On February 21, 1990, the Bureau of Land Management (BLM) received PacifiCorp's proposed Rilda Canyon Lease Tract addition for the Deer Creek Mine Permit Application Package (PAP). The BLM was asked to review the resource recovery and protection plan (R2P2) and submit our findings which are discussed below.

Re: Resource Recovery and Protection Plan (R2P2), PacifiCorp. Deer Creek Mine, Emery County, Utah

Re: Minor Modification of Resource Recovery and Protection Plan (R2P2), 1st Right Sub-Mains and Ventilation Portals, Hiawatha Seam, Deer Creek Mine

Enclosure:
Mine Projection Map

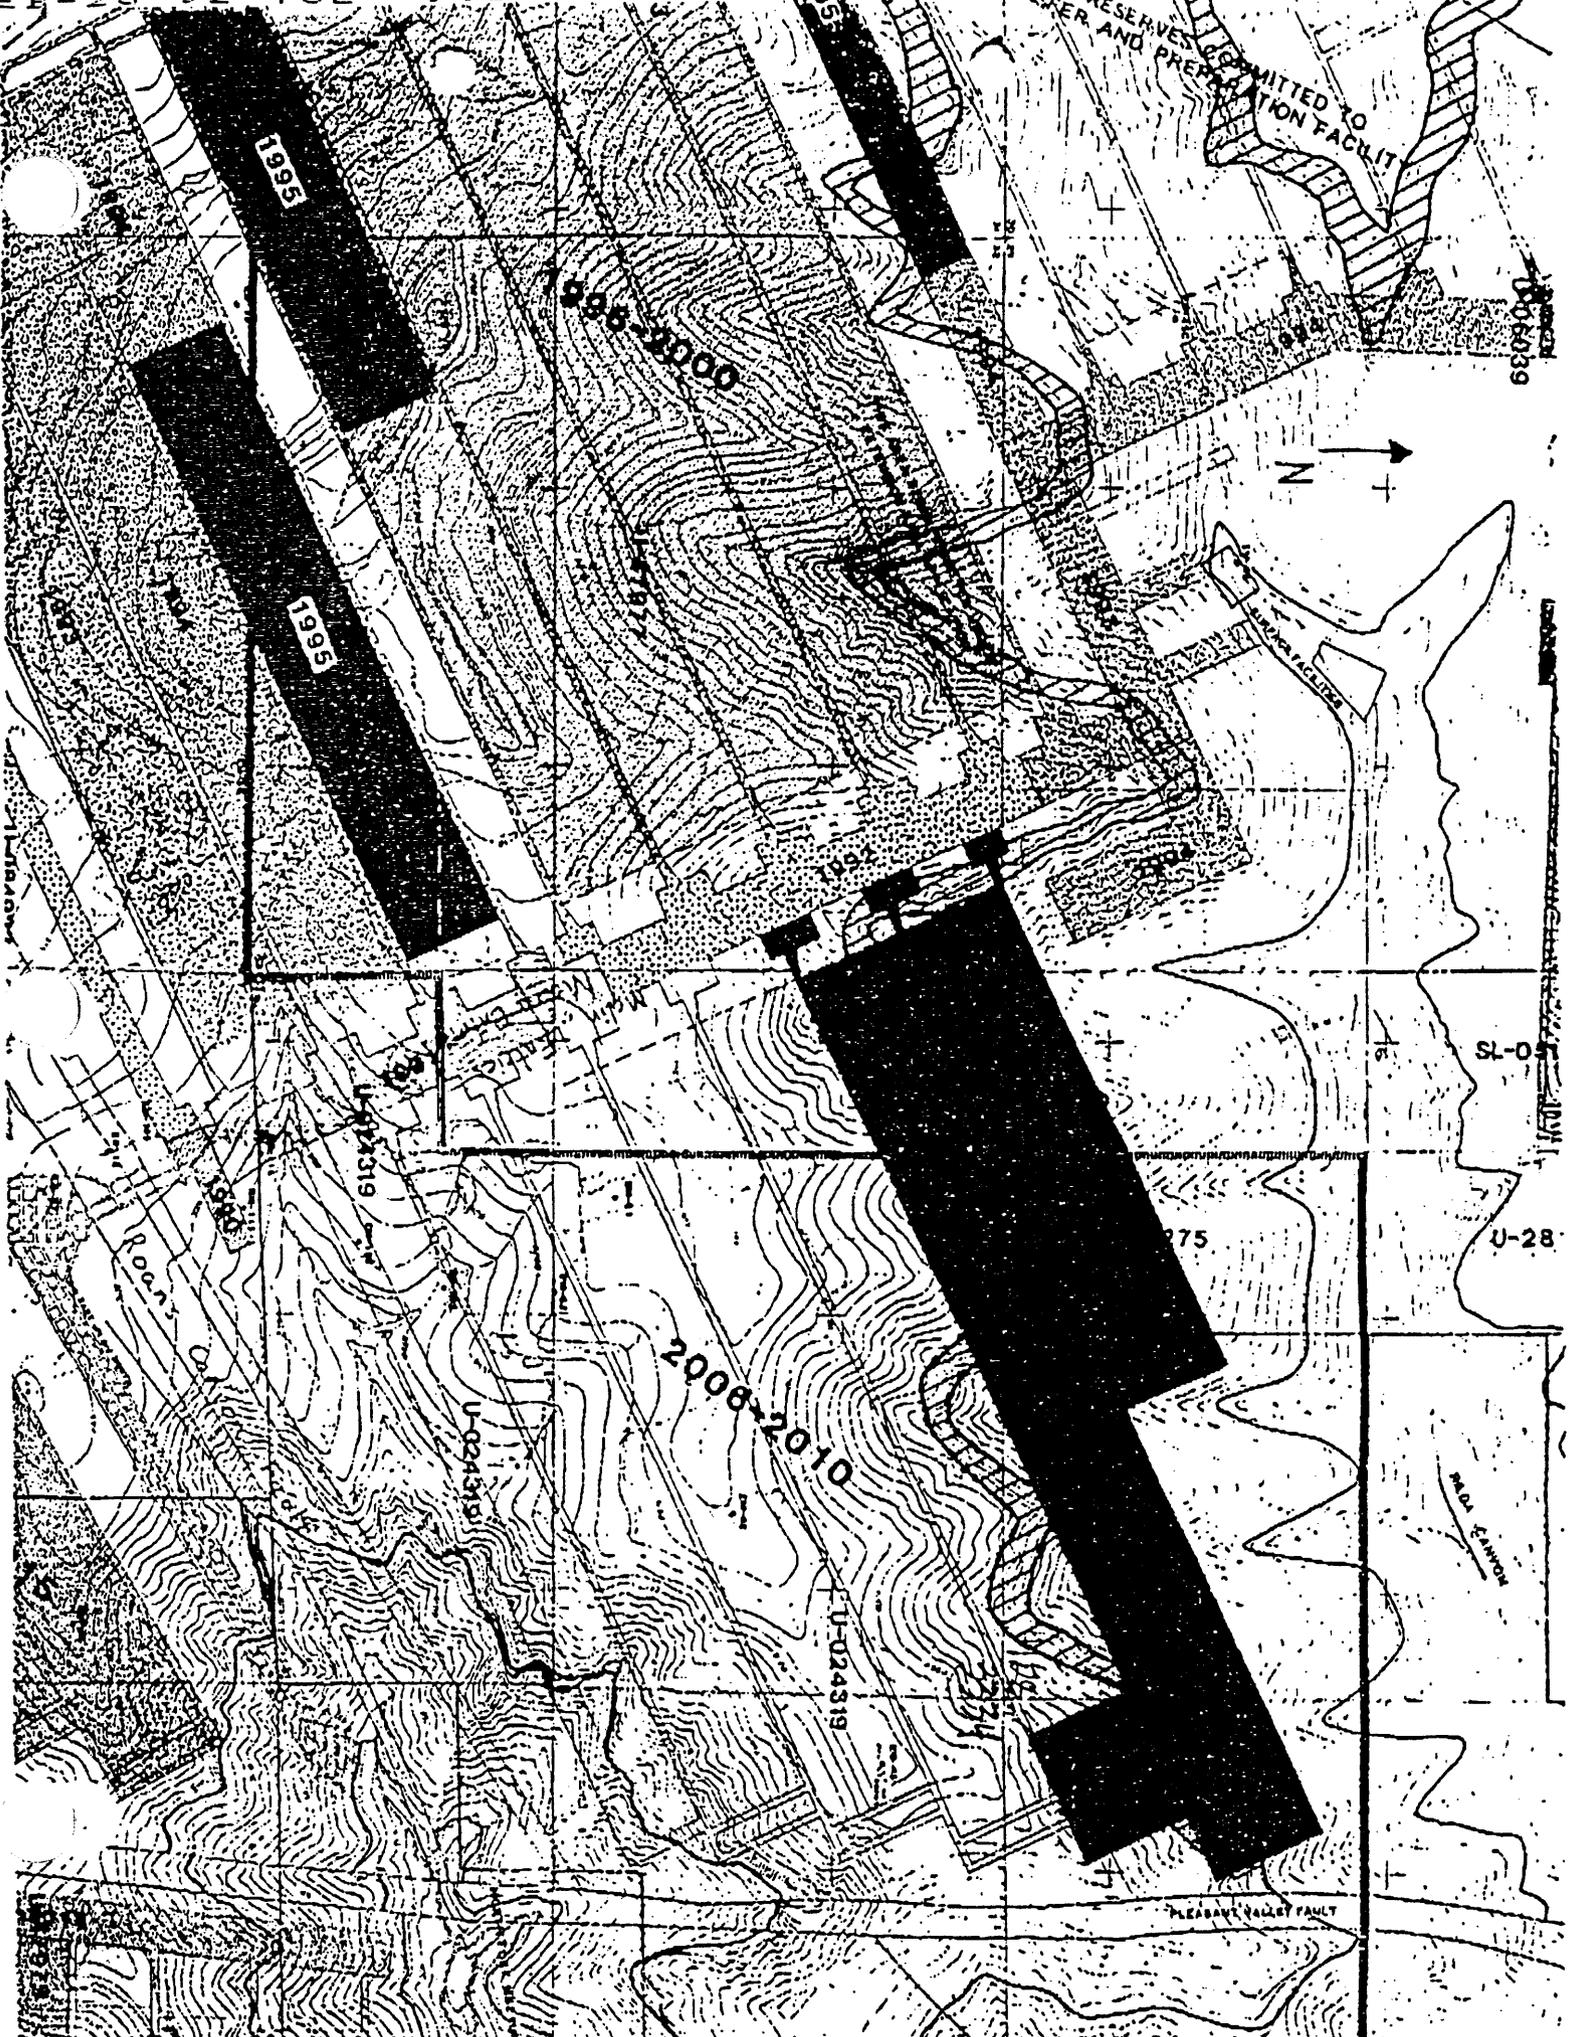
The R2P2 calls for the development of main entries in a north-northwest direction beyond the Roan's Canyon Fault. Longwall panels are projected on both sides of these main entries. A number of longwall panels located along the south side of Rilda Canyon will undermine portions of the canyon escarpments (see enclosed highlighted map). This has prompted an in-depth review of potential escarpment failure.

The Manti-LaSal National Forest (FS) has asked BLM to evaluate the R2P2 and determine if the mining plan provides adequate protection of surface resources in accordance with the Federal lease terms and conditions. The BLM is currently working on a response to the FS regarding our analysis of the escarpment issue. Final approval of mining zones that may affect sensitive escarpment areas is contingent on the completion of the technical studies currently underway. Because the mine plan provides adequate flexibility for any necessary future adjustments in these areas, development as proposed for the remainder of the R2P2 is recommended for approval.

We have determined that the R2P2 as submitted is complete and technically adequate. The R2P2 is also in compliance with the Mineral Leasing Act, as amended, the regulatory provisions of 43 CFR 3480, Federal lease terms and conditions, and will achieve maximum economic recovery (MER) of the Federal coal. Therefore, we recommend partial approval of the R2P2 for this permit action.
